**Interstate 580/Patterson Pass Road/International Parkway Diverging Diamond Interchange Improvements Project, CIP 73147, Federal Project Number: ACSB11M-580-1(982)E**

Subject: Addendum No. 5

**ADDENDUM NO. 5**

Dist	COUNTY	ROUTE	POST MILES TOTAL PROJECT	SHEET No.	TOTAL SHEETS
10	SJ	580	12.6/14.3	11	321

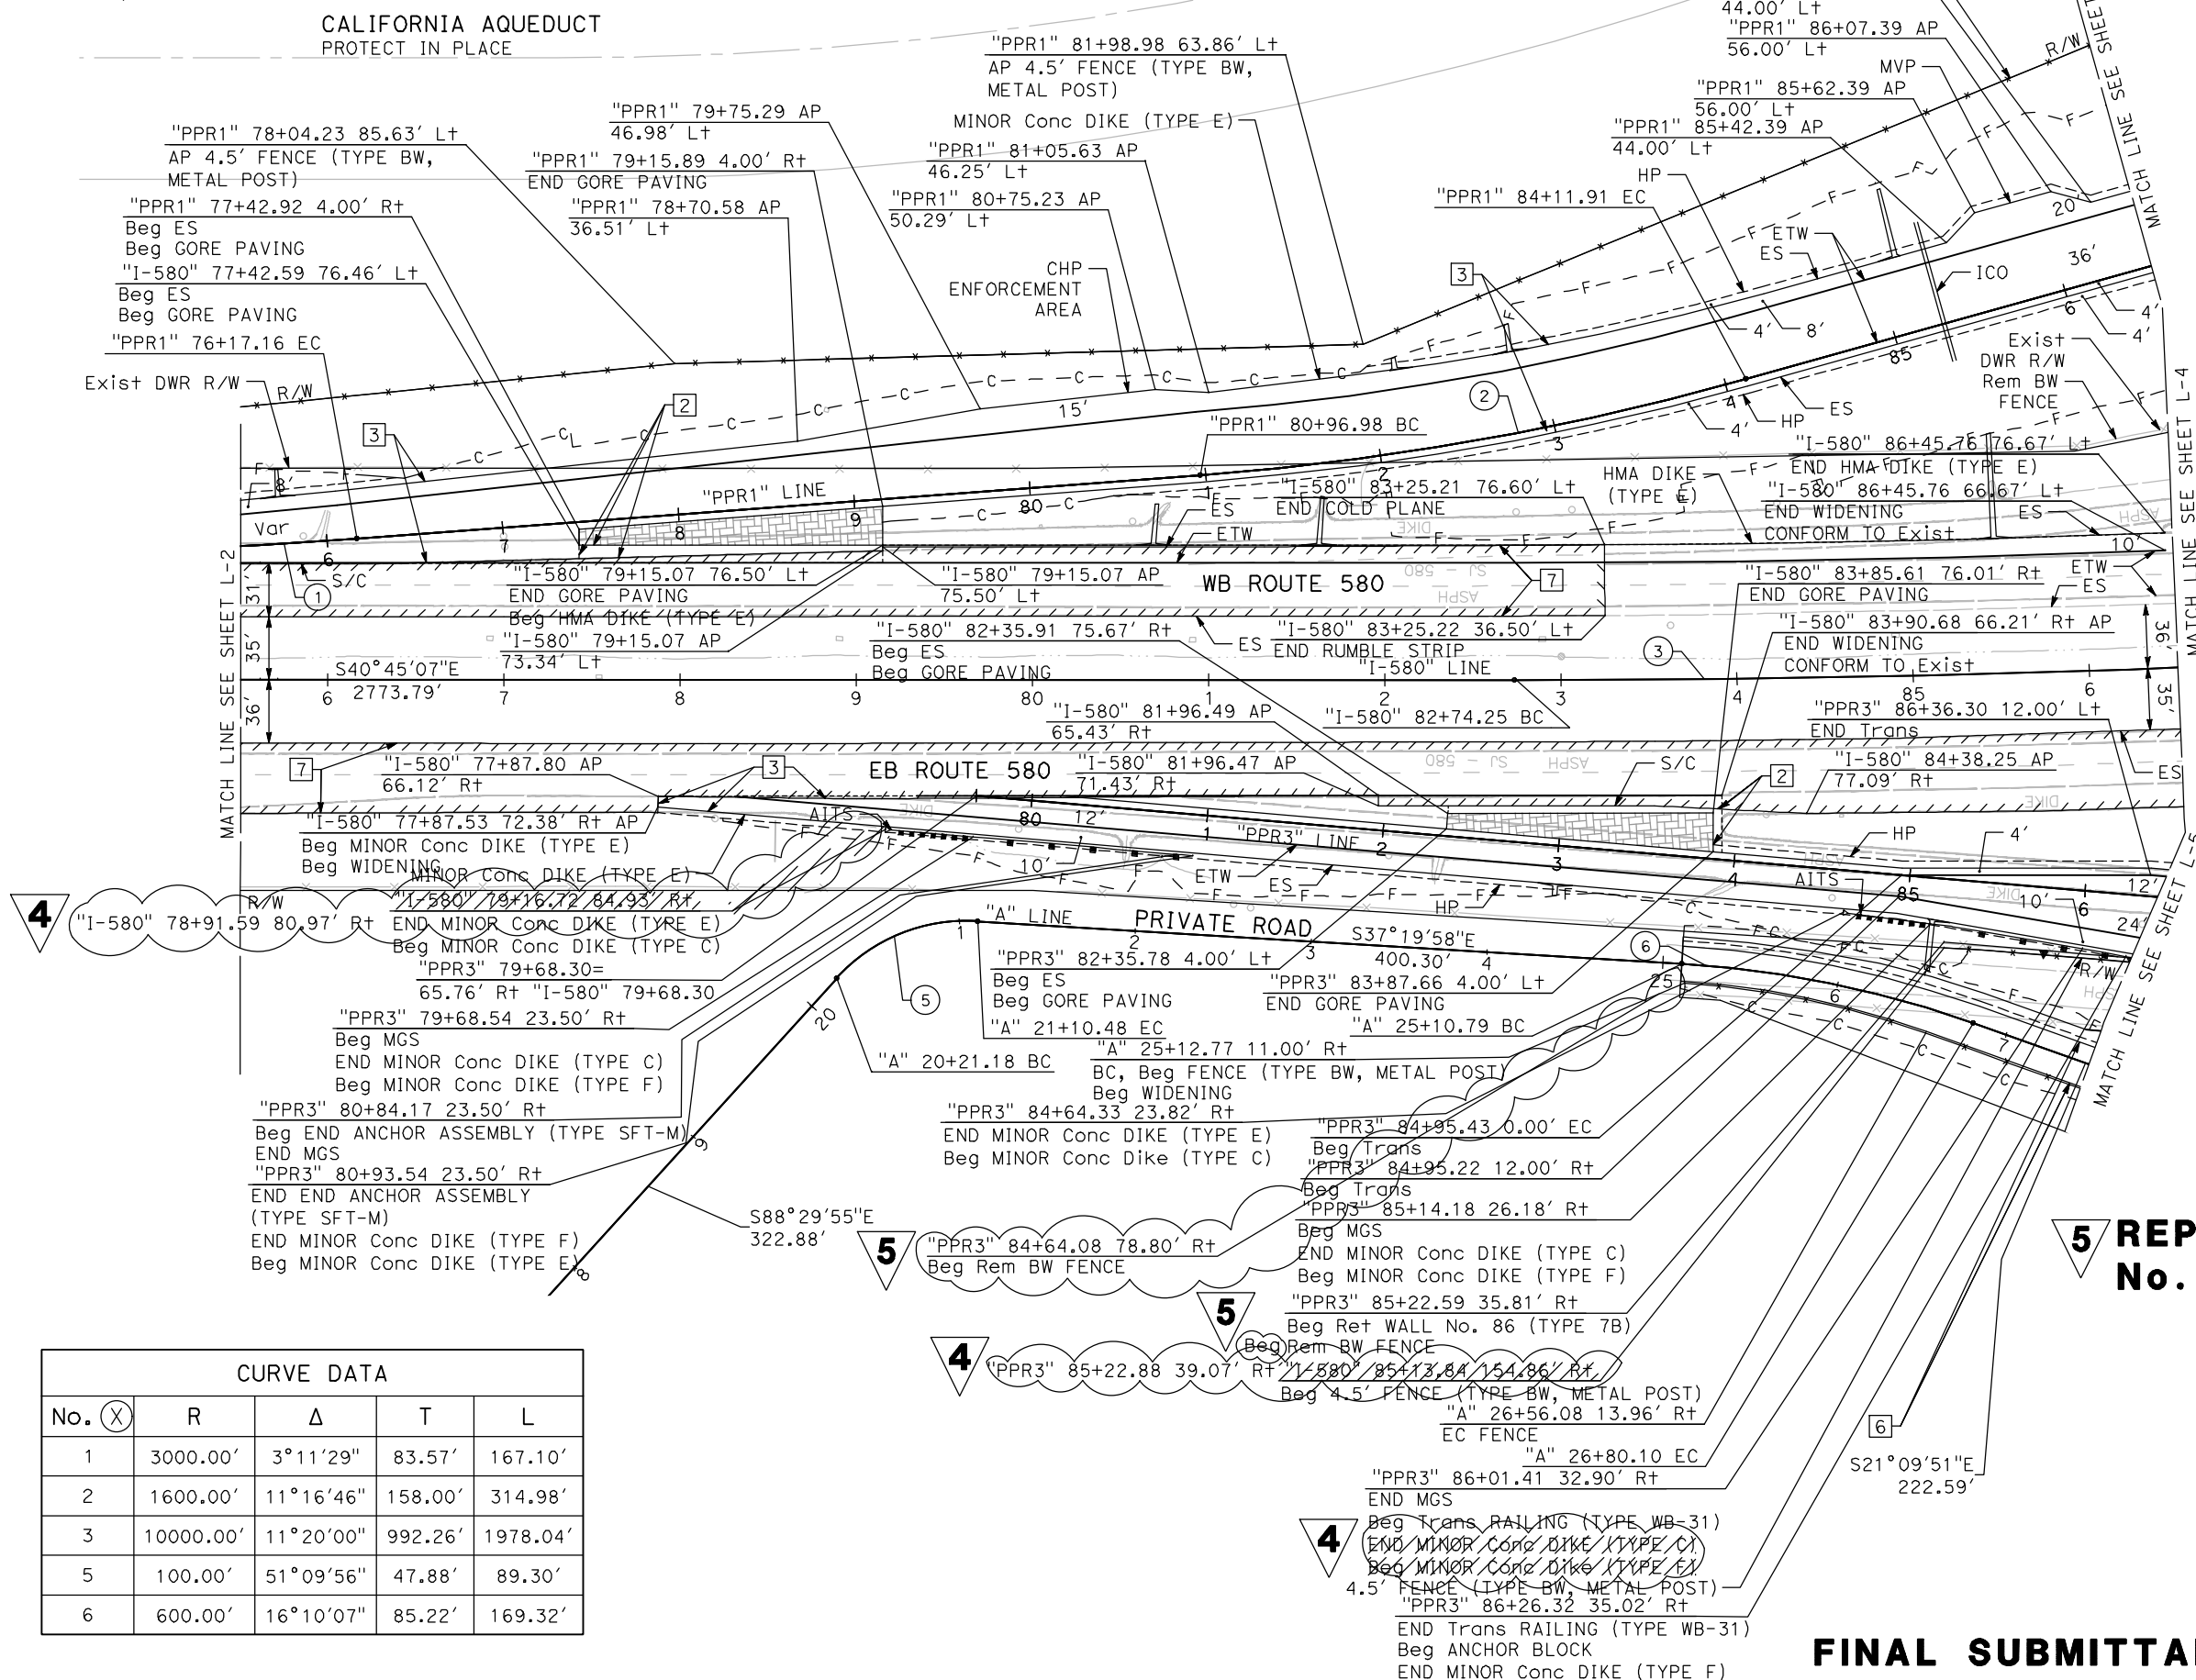
Q5.01 The existing Private Road, near PPR Line Sta. 46+50 has a metal pipe gate and metal pipe fencing that are not shown to be removed. We request the City confirm that these improvements do not require removal. If they require removal, we request the City provide a bid item for payment.

A5.01 See updated L-3, L-5, and C-27 for steel tubular post fence removal limits. Only the portion of the existing steel tubular fence along the Caltrans R/W will be removed to allow installation of new fence (Type BW). The existing steel tubular fence on private property outside Caltrans R/W including the pipe gate will remain. A new Bid Item "Remove Fence (Steel Tubular) is added for 120 LF. Note that there are notes on Sheet C-27 to relocate the existing mailbox and relocate a two-post sign. New Bid Items "Relocate Mailbox" and "Relocate Sign" are added for 1 EA for each item. Please refer to revised Bid Schedule (Attachment A).
